Technical Service Bulletin

LIFTGATE SWITCH DOES NOT WORK

Bulletin No.: 09-004/22

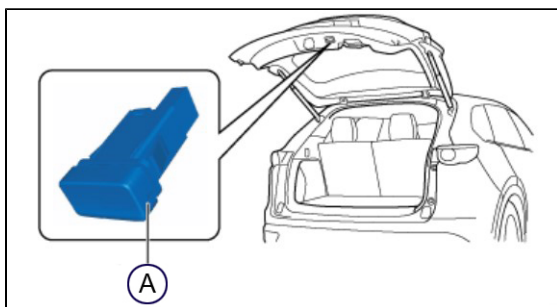
Some CX-5 and CX-30 customers may find that the liftgate does not close when pressing the power liftgate (PLG) rear switch (A) located on the interior liftgate trim. This may be caused by PLG switch corrosion. Water from a high pressure car washer and/or condensation may drip onto the switch connector and cause corrosion.

To eliminate this concern, the PLG rear switch has been modified with a waterproof connector.

Before Wrapping	After Wrapping

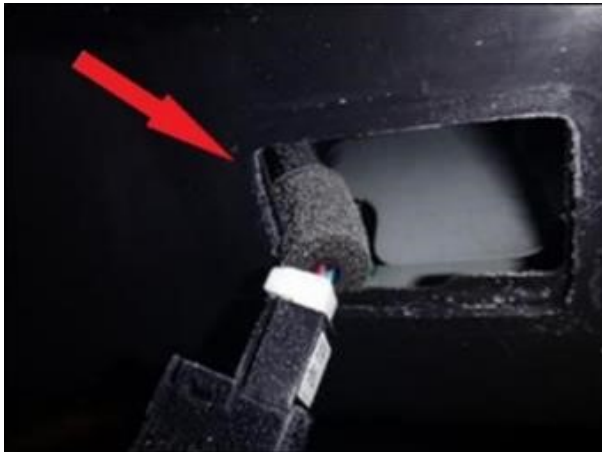
- While wrapping either upwards or downwards, use the half-overlapping method.
- To seal any possible gaps from water entry, stretch the tape a little to make it fit securely to the shape of the switch and coupler.
- In the image below, the thick foam rubber is not illustrated (the connector used for this photo did not have this part), but it is important as a position reference during the wrapping.
